PERRY NUCLEAR POWER PLANT
10 CENTER RD., PERRY, OHIO 44081

Information Only
New Figure

Information Only
CN=Change

Figure 2D-1

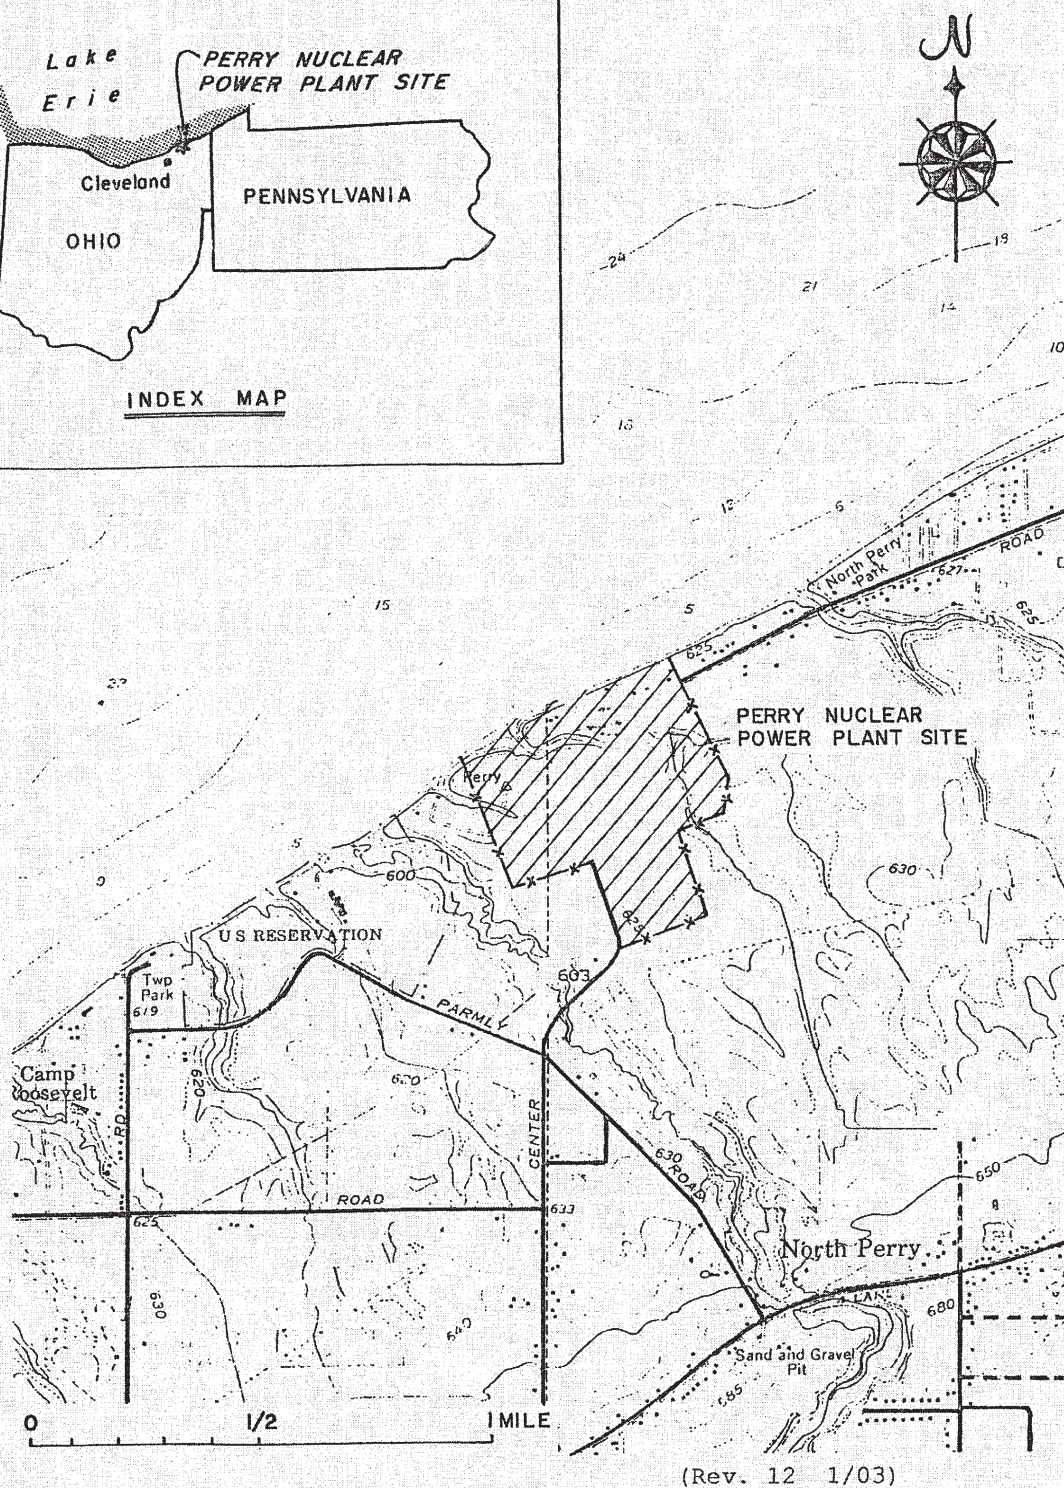
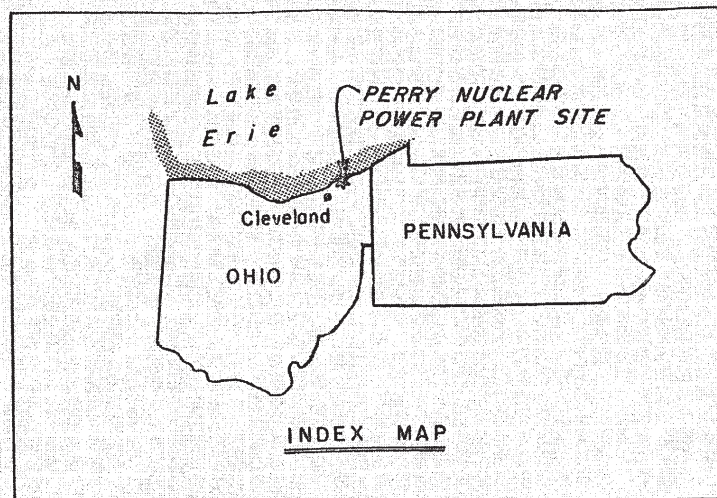
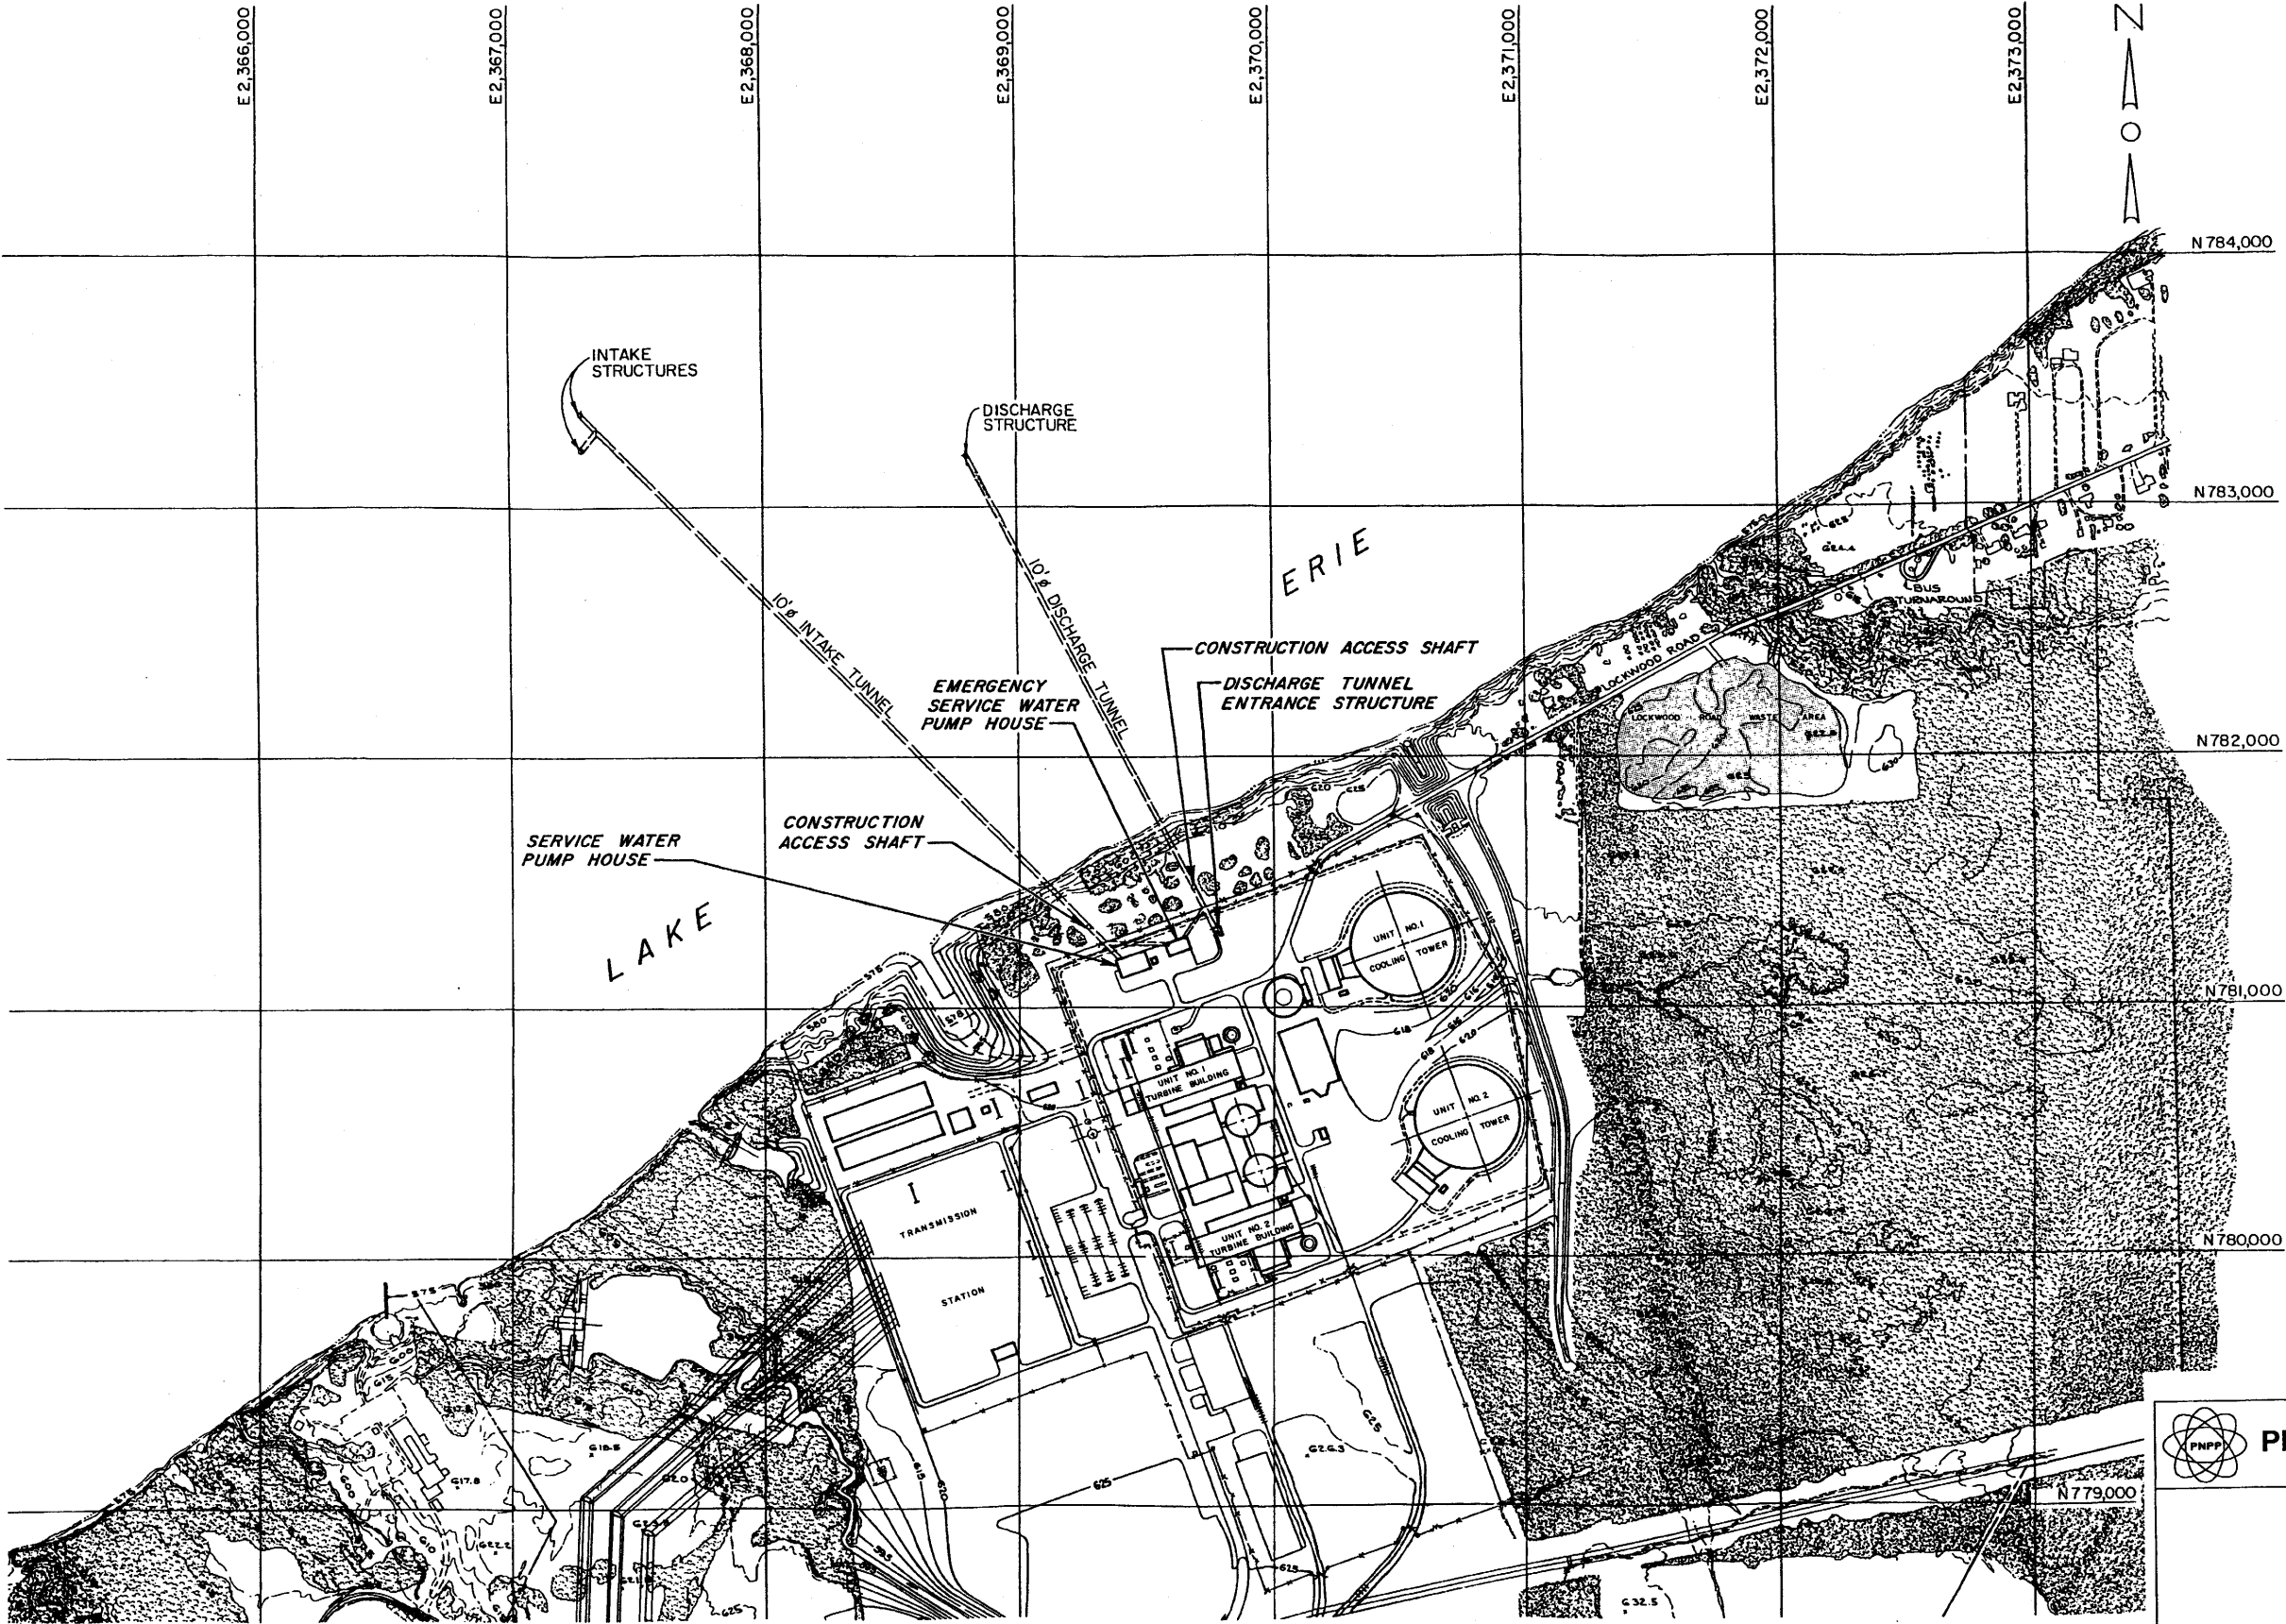
ADD NOTE
THIS CN

NOTE:
THIS USAR FIGURE CONTAINS
HISTORICAL TOPOGRAPHICAL
INFORMATION FOR REFERENCE
ONLY AND WILL NOT BE UPDATED.
